JAZZHOUSE

8.0 EDG SUMMARY

8.0 ITEMIZED RESPONSE TO EDG

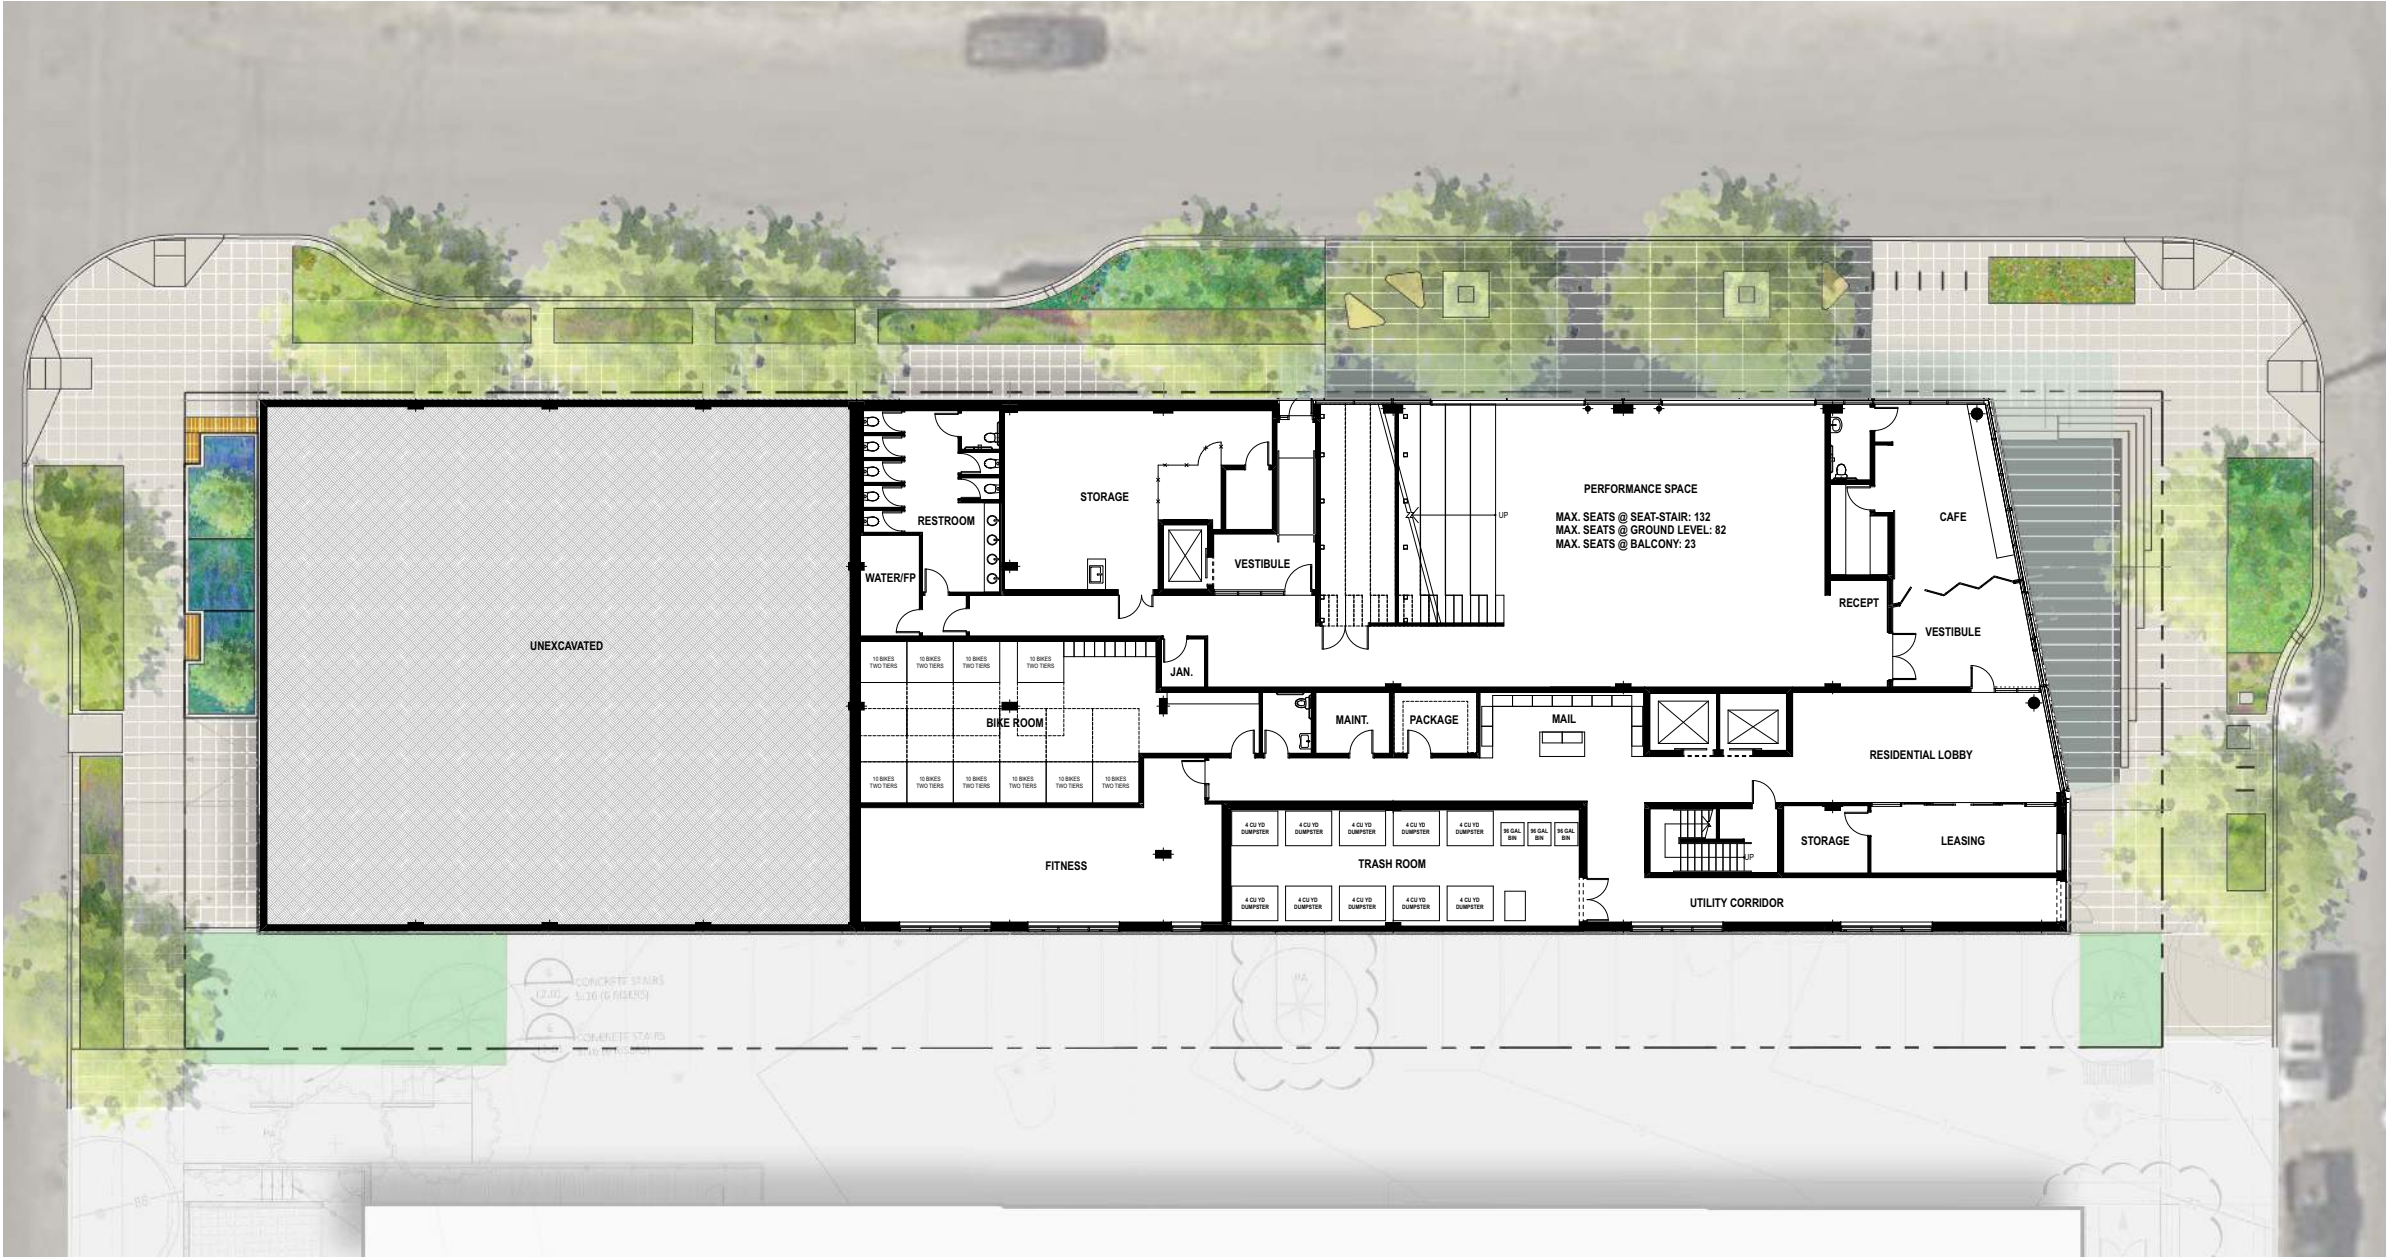
3c c) The design team shall provide additional details for where mail and packages will be delivered and/or picked up. (DC3-C-2, DC4-D-4)

Response: Residential mailbox stacks will be provided for residents within the residential lobby, on the east side of the building. JazzEd will receive mail and packages at the reception desk adjacent to the entry.

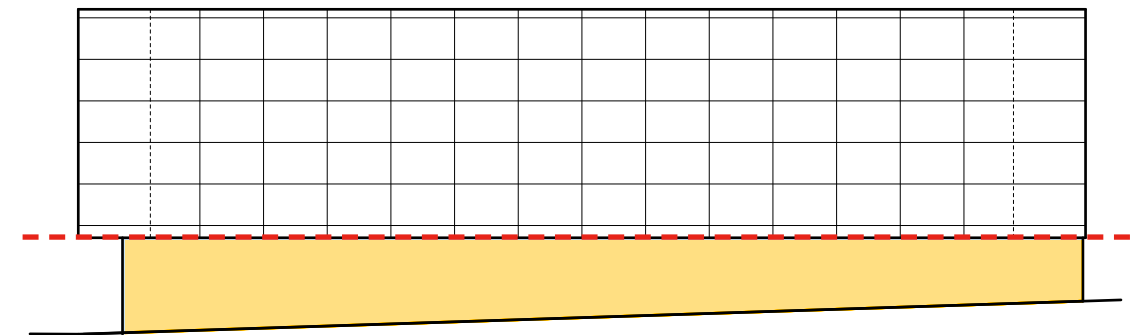
4b b) Staff generally supports the design of the streetscape along 21st Ave S, which includes bench seating, street trees and bio-retention. Staff requests additional explanation and vignettes demonstrating how and why these spaces will be used. In addition, the design team shall provide additional design details for the green triangular areas located at the building's southwest and southeast corners, identified as vegetation as seen on page 44 of the EDG packet. (CS2-D-5, PL1-B-3, PL3-A-4, DC3-C-2, DC4-C)

Response: Landscaping is used to enhance both the building and its pedestrian realm at street level. Street trees, a landscaping buffer, and curb bulbs at S Hill St and 22nd Ave are provided to aid in shading the pedestrian street and enhance pedestrian safety from the moving cars.

Street level bioretention planters engage the public with the stormwater management process and natural seating opportunities. The paved urban plaza extends the width of the sidewalk to capture a gathering space adjacent to the performance space, punctuated by wood-top benches for additional seating and bike racks for visitors and commuters.

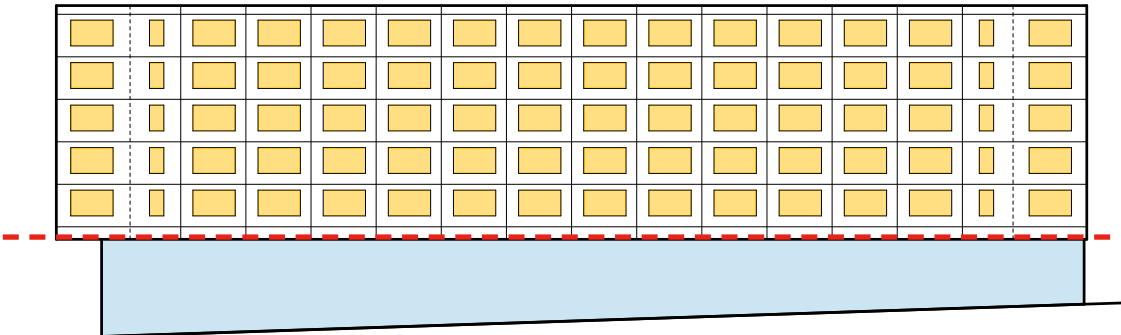
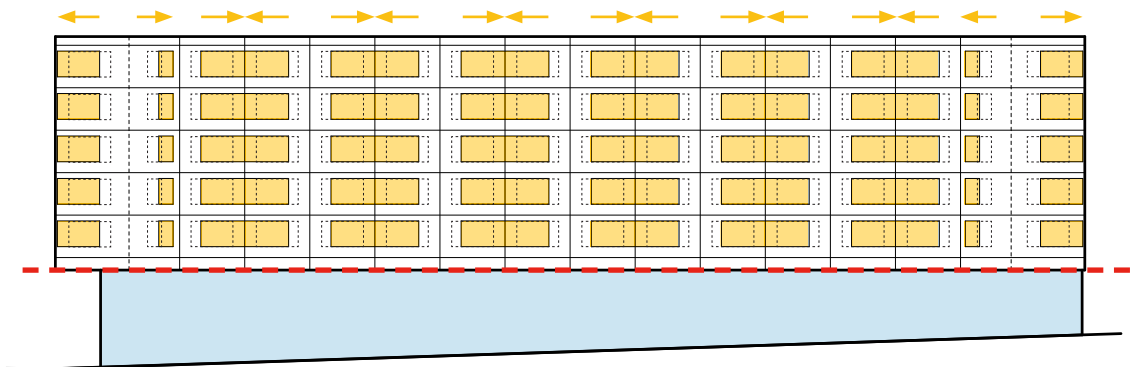
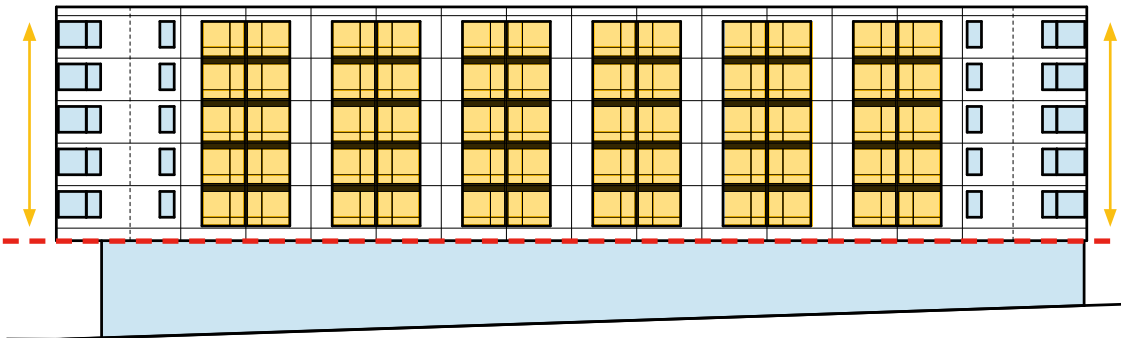
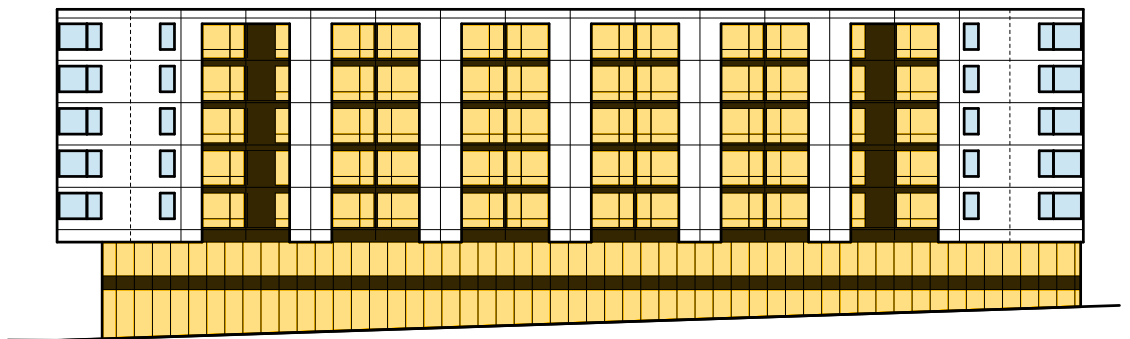
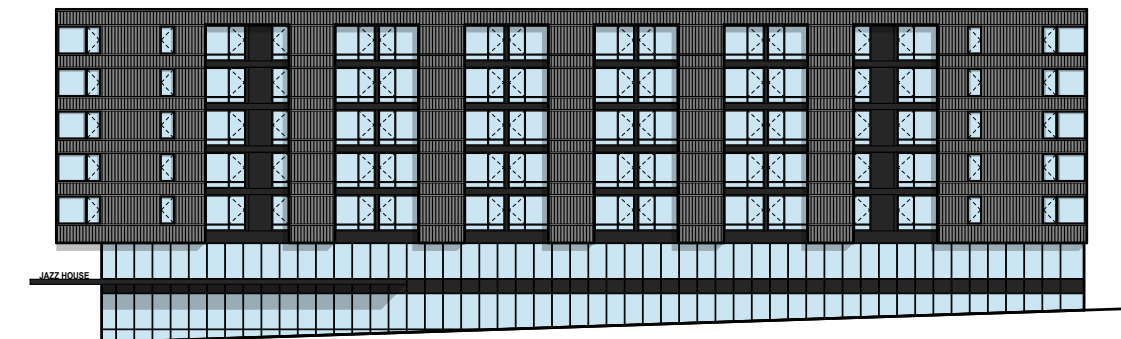
5a a) *Materials and façade treatments will be critical to the success of the massing. As such the design team shall explore different ways of applying material and textures to create greater visual interest along all building facades (DC4-A-1, DC4-C, DC4-D-2,)*

Response: The exterior building materials have continued to be developed with scale, texture, and visual interest in mind. At the lower floors, a blackened metal and wood canopy has been refined with rhythmic structural bays to add visual interest and better relate to the human scale. The concrete foundation walls will integrate a community artist's design. The upper mass has been designed with a preformed, metallic finish metal panel of varying widths in a alternating pattern to provide a holistic visual texture across the façade. These is broken up by windows with extruded trim for depth and shadow lines while the transparent bays are offset for further depth. Colors have been selected for the complimenting tones, textures, and reflectance.

Residential Trash Staging

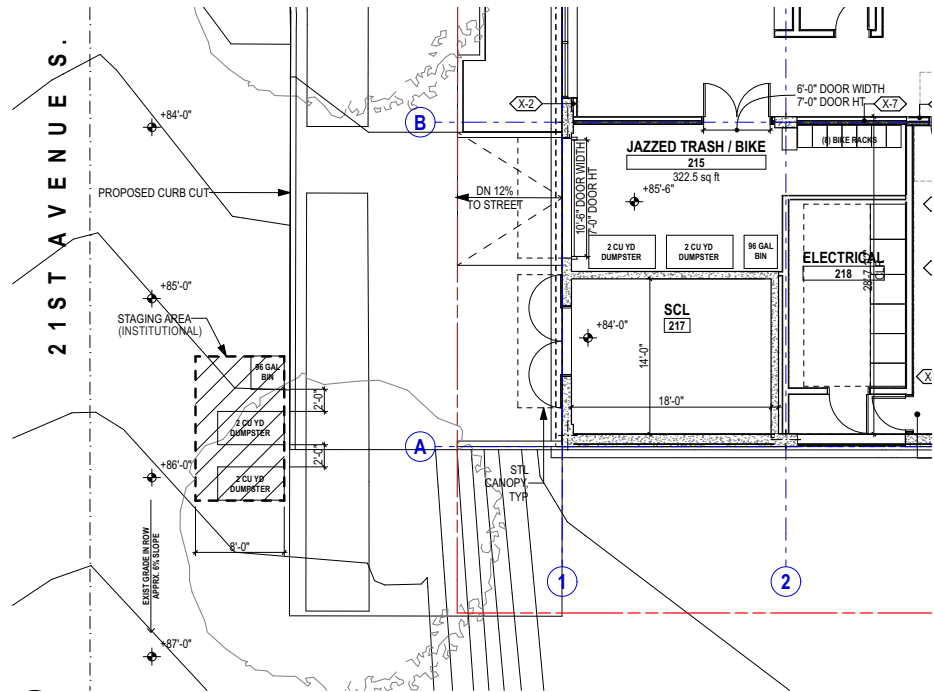
6a a) The design team shall provide the methodology and location for all trash staging on pick up days. (DC2-B-1, DC1-C-4)

Response: Separate trash rooms are provided for JazzEd and the residents, located to best correspond to internal accessibility. Trash staging areas for pick up will be located in two areas corresponding to the trash room locations, coordinated with SPU, and positioned as far from building entrances & street intersections as possible. The JazzEd trash staging will occur on 21st Ave S at the southwest corner of the site. The residential trash staging will occur on 22nd Ave S at the southeast corner.

Pickup day(s) will be coordinated with SPU. The building operators will move containers out for pickup on the morning of and return them to the trash rooms once picked up.
